# WECC Regional Planning Review

Canada/Pacific Northwest – Northern  
California Transmission Line Project

Technical Analysis Committee Report

November 1, 2007

Figure 1: Proposed conceptual transmission plan for WECC Phase 1 Rating Process

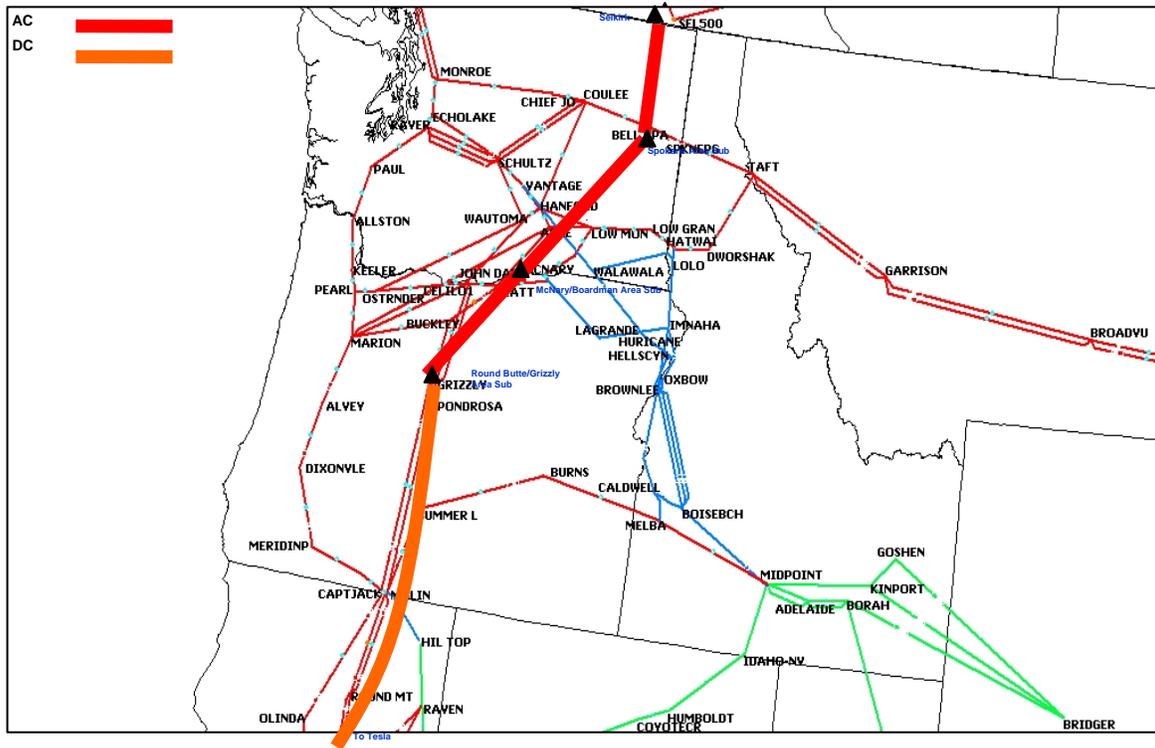
3. **Comment:** Round Mountain Substation -- This is something new. Why is this potential third terminal being considered?

8. **Comment:** I do not recall much discussion on this one. Round Mountain seems out-of-the-way from Raven.

**Response:** Round Mountain substation may be a potential third HVDC terminal to facilitate transfers of renewable resources that may develop in Northern California and Nevada to the load centers in the Sacramento and San Francisco Bay area.

**Response:** please see the response 3 above and also in their proposed transmission plan, TANC is exploring alternatives for transmission connection between Northeast California to Elverta area via Round Mountain substation.
